UNITED STATES DEPARTMENT OF COMMERCE
National Oceanic and Atmospheric Administration
NATIONAL MARINE FISHERIES SERVICE
West Coast Region
1201 NE Lloyd Boulevard, Suite 1100
Portland, OR 97232

Re: National Marine Fisheries Service (NMFS) comments on Columbia Generating Station National Pollutant Discharge Elimination System (NPDES) Permit No. WA-002515-1 and accompanying Fact Sheet

Re: Columbia Generating Station Cooling Water Intake Screen
NMFS Consultation No. (I/NWR/2011/05286)

SUBJECT: Columbia Generating Station (CGS) – Intake Screens Assessment and Recommendations for Modifications

Figure 1. - Length-frequency of 0-age fall Chinook salmon collected with fyke nets: a) barge sets and b) shoreline sets (from Dauble et al, 1989)

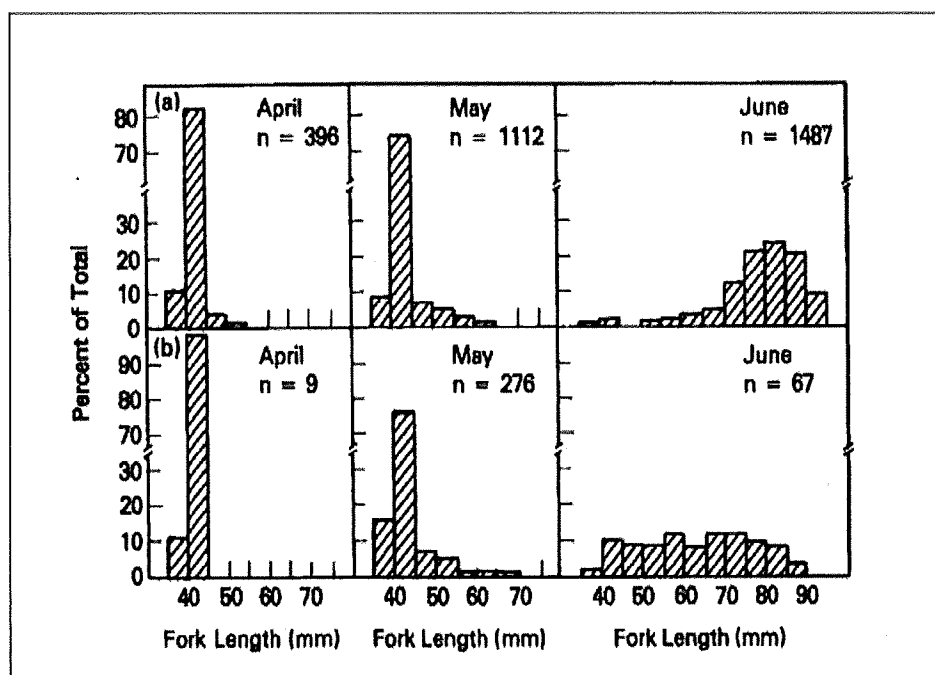
The second is “Spatial Distribution of Juvenile Salmonids in the Hanford Reach, Columbia River”, authored by Dennis D. Dauble, Thomas L. Page and R. William Hanf, Jr., and published in 1989 in Fishery Bulletin, U.S. 87:775-990 (Dauble report). The Dauble report consists of study results showing fish capture from deployment of fyke nets in the Hanford Reach in the vicinity of the CGS intake screens, with the fyke nets set in an array representing the entire cross section of the Columbia River.

salmonids in the early 1990's (Bates and Fuller, 1992) (Beecher, 1993), and later modified by considering the results of a screen evaluation at the Dryden canal (Mueller et al, 1995) (PNNL, 1994). When applied, these criteria generally provide protection to greater than 98% of the juvenile salmon, for fish larger than the button-up fry life, under the coldest water temperatures likely to exist when these fish are present. Generally, Chinook and steelhead fry are not migratory, but are sometimes prone to be swept downstream by freshet flows, and will also move around to forage. Occurrence of either of these events could place fry in the vicinity of the CGS intake screens and vulnerable to entrainment. Zero-age juvenile Chinook and steelhead are actively foraging, moving from shallow waters to deeper waters depending on a number of factors. In a fyke net study conducted in the vicinity of the CGS intake, zero-age fall Chinook salmon occurred primarily in shoreline areas of reduced current velocity (see Figure 1), but were present throughout the river cross section during their early rearing and outmigration period (Dauble et al, 1989). These fish are susceptible to entrainment through the CGS intake screens.
